MEMO

To: Kristopher Byrd, Well Construction and Compliance Section Manager
From: Joel Jeffery, Well Construction Program Coordinator
Subject: Review of Water Right Application G-18327
Date: December 12, 2016

PUBLIC INTEREST REVIEW FOR GROUNDWATER APPLICATIONS

TO: Water Rights Section Date November 15, 2016
 FROM: Groundwater Section Aurora C Bouchier
 Reviewer's Name
 SUBJECT: Application G- 18327 Supersedes review of na
 Date of Review(s)

Stream Depletion Model Result

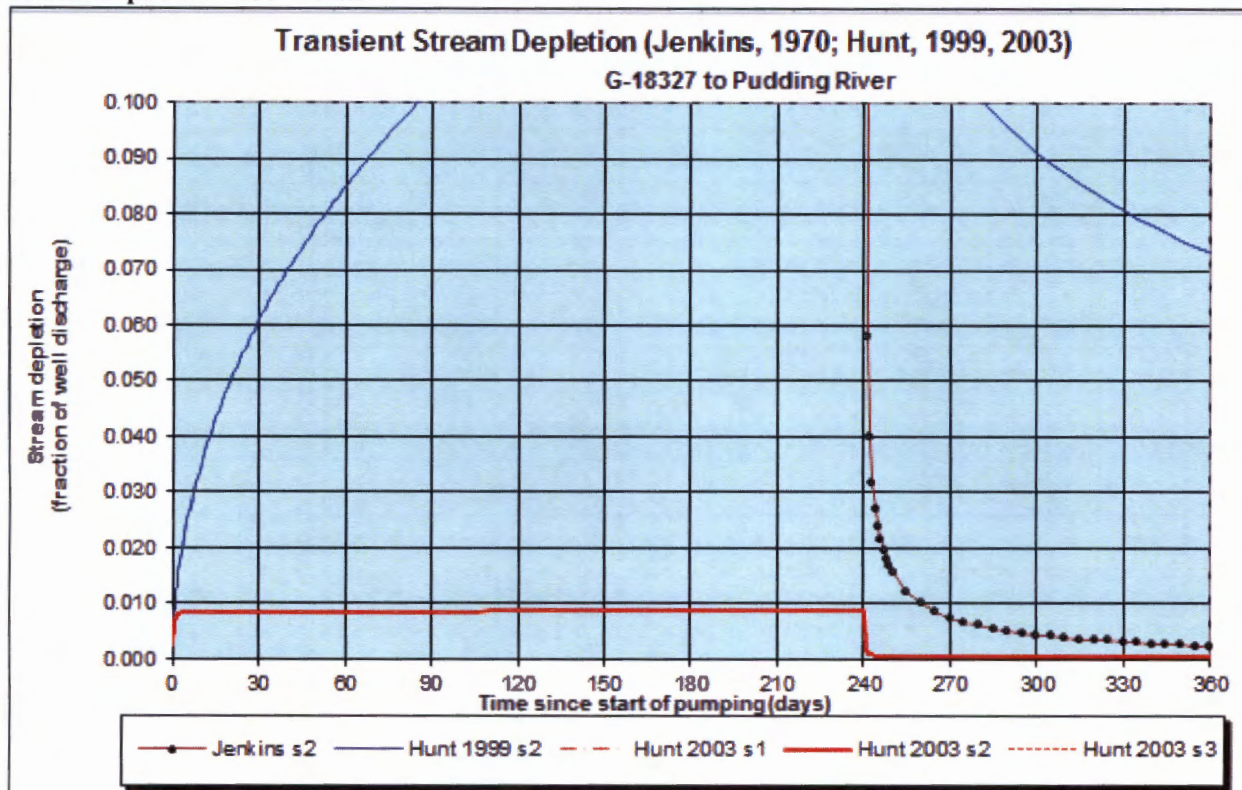
Comments: The wells closest to the streams (Well 1 for the Pudding River, and Well 3 for the Creeks) was modeled at the full proposed rate (not the stacked rate). The stream depletion at 30 days was estimated using the Hunt 2003 model. The presence of low permeability Willamette Silt between the aquifer and the beds of the streams result in an inefficient connection between the aquifer and the streams. Therefore, the stream depletion at 30 days is likely to be << 25%.
